**From:** Eudy, Michael  
**Sent:** Tuesday, March 29, 2011 8:22 AM  
**To:** Roach, Edward; Hinson, Charles; Stutzcage, Edward  
**Cc:** Wunder, George; Tonacci, Mark; STPCOL  
**Subject:** FW: 12.02-20 revised response  
**Attachments:** 12\_02-20-RR-00\_Draft-14.pdf

## RAI 12.02-20

## 12B Spent Fuel Pool Geometry and Dose Rate Calculation

Figure 12B-1 SFP Layout and Dimensions

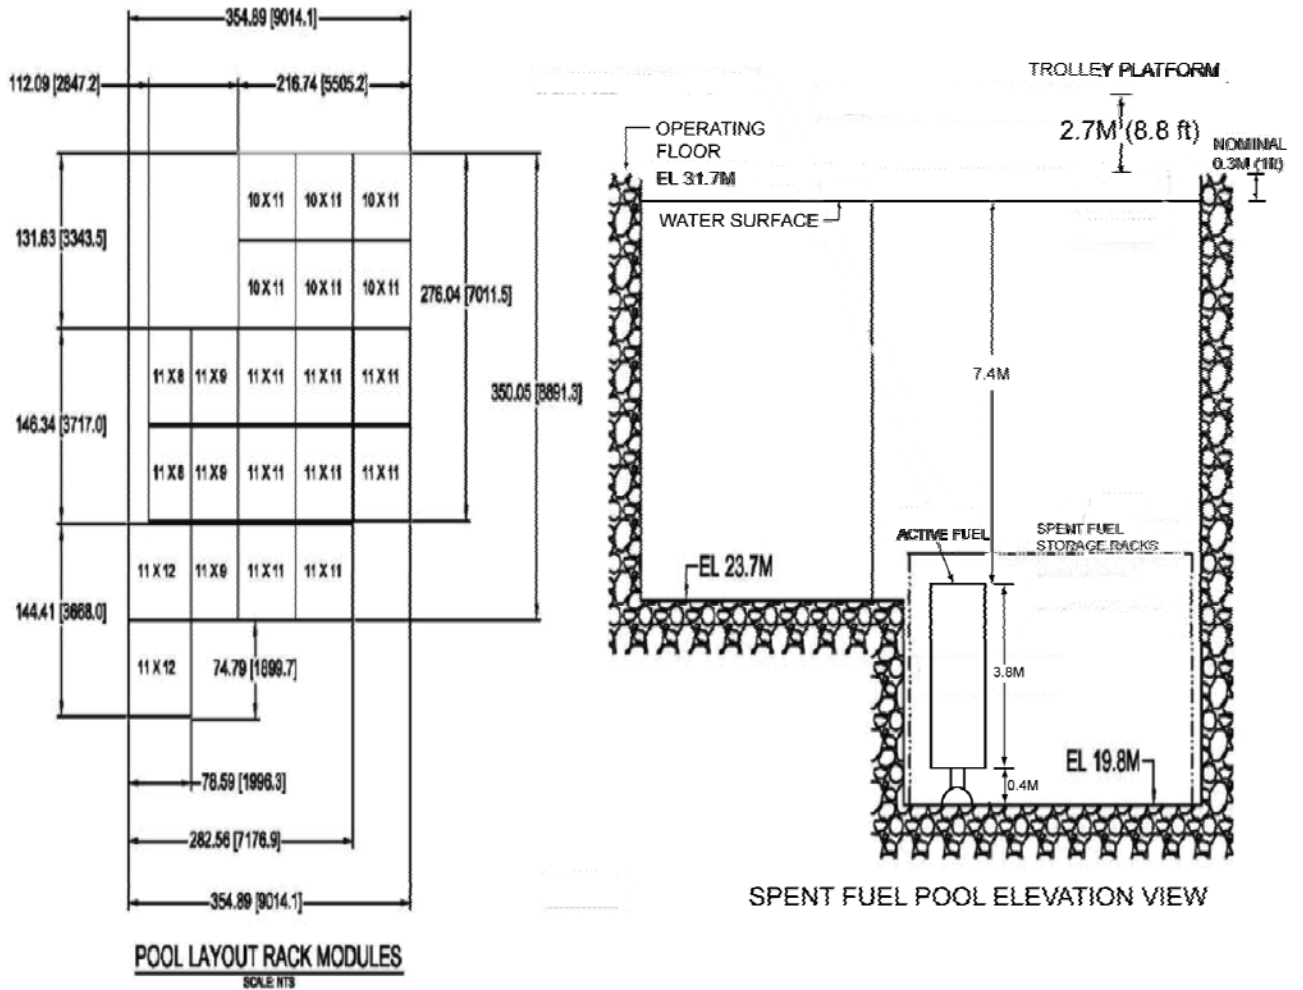
2. A figure was included in the RAI response showing a vertical cut view of the SFP. Some of the dimensions on the figure appear to be inconsistent with the spent fuel storage shielding dimensions shown in Table 12.2-5c of the ABWR DCD and STP 3&4 FSAR. In addition, this figure does not include some of the dimensions and spatial relationships needed by the staff to perform a shielding calculation. Specifically, there appears to be an inconsistency between the depth of water above the fuel assemblies as shown in the SFP figure and the depth of water as indicated in Table 12.2-5c. In addition, the figure does not show the minimum distance between the top of a raised fuel assembly at maximum height and the SFP water surface, the height of the SFP fuel pool bridge above the water surface, and the location of refueling personnel during refueling operations on the fuel pool bridge. In order for the staff to be able to perform an accurate deep dose equivalent calculation for a person standing on the fuel pool bridge, please provide an updated figure of the SFP, addressing these items.

1. The new Appendix 12B shows a representative SFP rack modules layout drawing (Figure 12B-1), with a capacity of 2365 bundles, which is conservative for a dose calculation compared to the maximum 270% (2354) bundles allowed in the SFP, as specified in FSAR Section 9.1. As discussed in the appendix, the radioisotope inventory and gamma and neutron sources, as a function of time post-irradiation, were calculated with the NRC-endorsed ORIGEN-S Code. The supporting proprietary calculations are referenced in this revised response as References 1 and 2.

2. ABWR DCD Table 12.2-5c shows spent fuel storage with 7.4 m of water above the fuel elements stored in the racks at the bottom of the pool in the fully seated storage position. This is consistent with ABWR DCD Figure 12.3-10, which shows the depth of the spent fuel storage pool as 11.9 m (31.7 m – 19.8 m). Reducing this value by the length of the active spent fuel (3.8 m) plus an additional conservative 0.4 m for the support portions of the bundle and rack seat height at the pool bottom, and approximately 0.3 m for pool water surface level depth below the operating floor results in slightly more than 7.4 m of water above the top of the active spent fuel seated in the racks.

As requested, the following information is provided. The refueling machine design discussed in Reference 4 shows the trolley platform approximately 8.8 ft (2.7 m) above the refueling floor. The refueling machine will have both local and remote controls. An improvement over some other machines allows the operator to locally control motions of the bridge, trolley, and all hoists and grapples from the trolley platform as opposed to operation of auxiliary hoists from the lower bridge. The remote control system consoles will be located in a control room on the refueling floor, providing the operator with all required functions for automatic control of fuel handling. As discussed in FSAR Subsection 9.1.4.1, the fuel grapple design will maintain adequate water shielding of at least 8.5 ft (2.6 m) over the top of the active fuel.

The SFP geometry is provided in FSAR Section 12.2, Tables 12.2-5a and 12.2-5b; and FSAR Section 12.3, Figures 12.3-6 and 12.3-10. The SFP storage rack has the capacity for 2365 BWR fuel assemblies. The size and configuration of the storage rack are given in Figure 12B-1, which shows an irregular rectangular cross-section area extended to 10.7 m x 9.0 m. The fuel storage rack is situated at the lowest level of the SFP, where the total height of water is 11.6 m.

Figure 12B-2 SFP Centerline Dose Rate

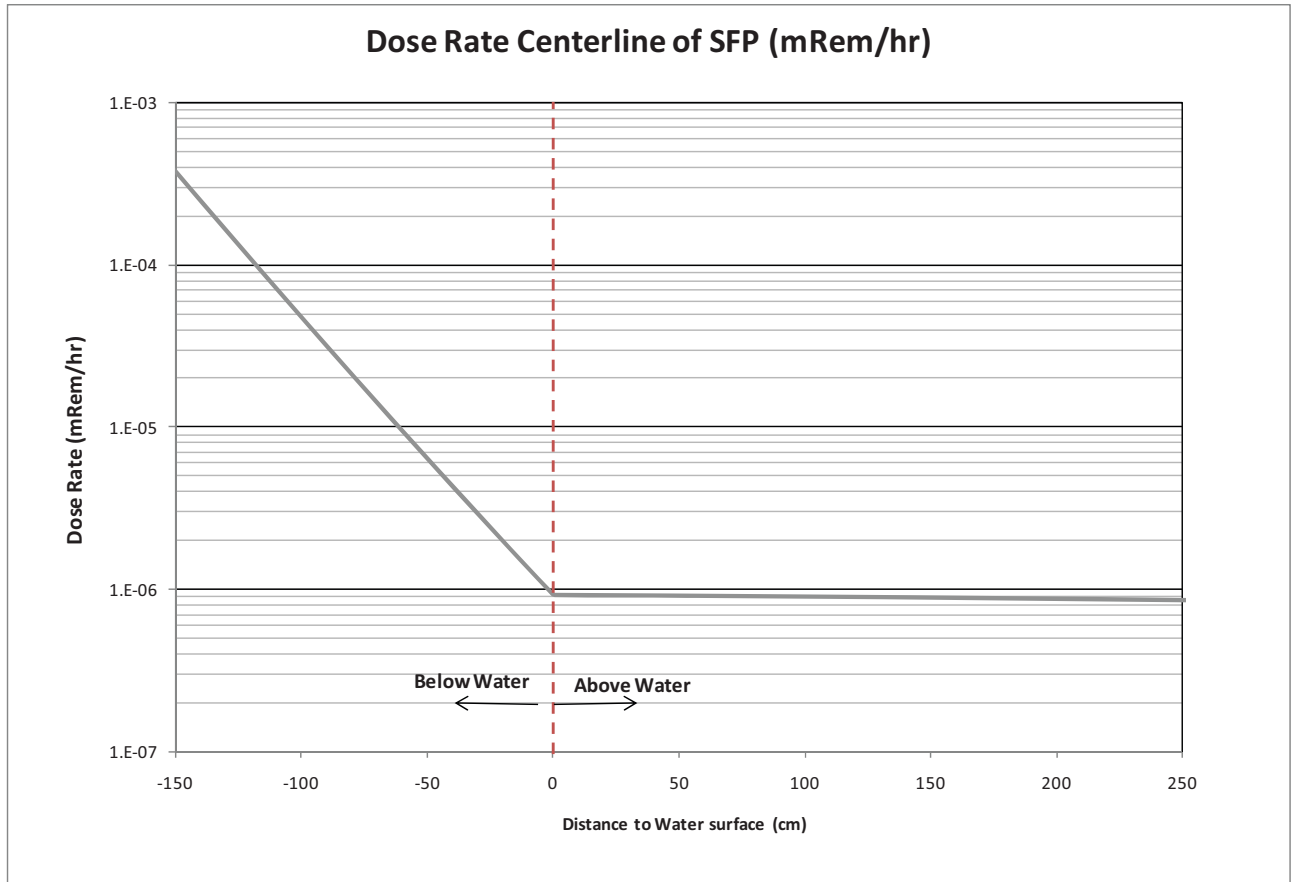
5. ABWR DCD Chapter 12 figures provide radiation zone maps for areas adjacent to the spent fuel storage room. Please confirm that the dose rates in areas adjacent to the SFP room will be no higher than what is indicated in the ABWR DCD Chapter 12 figures and include any changes in estimated dose rates in the Chapter 12 FSAR radiation zone maps.

The SFP radiation source is used for the shielding design and analysis to ensure radiation levels at neighboring areas surrounding the SFP meet the design criteria. A simplified model of a rectangular parallelepiped of (8.1 m x 8.1 m x 11.2 m) is assumed to represent the SFP. The SFP peak radiation source is assumed to be homogenized over the bottom 3.8 m of the SFP to represent the active fuel length of a typical BWR fuel assembly. There are 2 m thick concrete walls surrounding the SFP on all sides. The floor of the SFP is 2 meters thick as well. The dose rate calculations are carried out with the point-kernel shielding code QAD-CGGP-A (Reference 12B.6-2). The calculated dose rate results indicate all the areas surrounding the SFP meet the reactor building (R/B) radiation zone limits. Figure 12B-2 shows the dose rate profile for a set of detectors along the centerline of the SFP perpendicular to the water surface. Dose rate at the water surface is approximately 0.001  $\mu\text{Rem/hr}$  ( $1\text{E-}5$   $\mu\text{Sv/hr}$ ). The dose rates assessed are due to fuel assemblies in the SFP alone. Contributions from contaminants in the SFP water are not included.

**Figure 12B-3 Maximum Single Bundle Dose Rate at Refueling Platform**

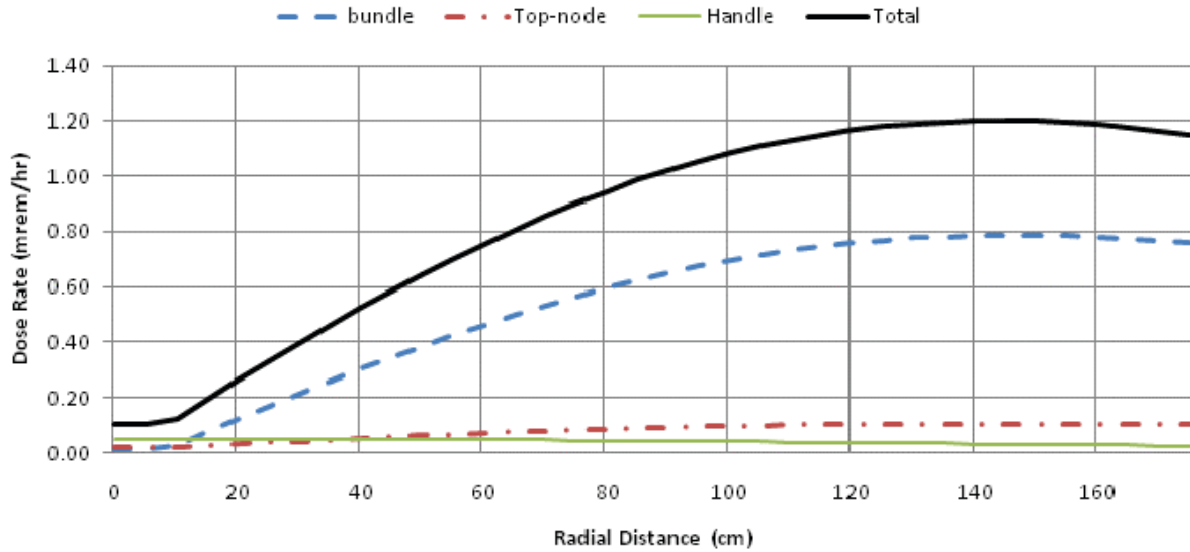
3. As stated in the response to 1. above, additional information is needed in order to perform a radiation dose calculation for workers standing on the fuel handling bridge. During refueling operation ANSI/ANS-57.1-1992 states that fuel handling equipment shall be designed so that the operator will not be exposed to >2.5 mrem/hr (25  $\mu$ Sv/hr) from an irradiated fuel unit, control component, or both, elevated to the up-position interlock with the pool at normal operating water level. Verify that the maximum dose rate to an operator on the fuel handling bridge will not exceed the 2.5 mrem/hr criteria stated in this ANSI/ANS standard.

It is assumed that the fuel assembly is lifted to a height of 8.5 ft (2.6 m) below the pool water surface with the operator on the refueling machine trolley platform at a minimum of 8.8 ft (2.7 m) above the water surface. The resulting peak dose rate at 8.8 ft (2.7 m) above the water surface is approximately 1.2 mRem/hr, located at a radial distance from the fuel assembly of approximately 140 cm (4.6 ft) as shown in Figure 12B-3. Even when the maximum fuel pool water source (see Section 12B.5 below) is added, the dose rate remains below 2.5 mRem/hr. For an operator standing on the trolley platform, the dose rate will be less than that shown in Figure 12B-3; therefore the design criteria of ANSI/ANS-57.1-1992 has been satisfied.
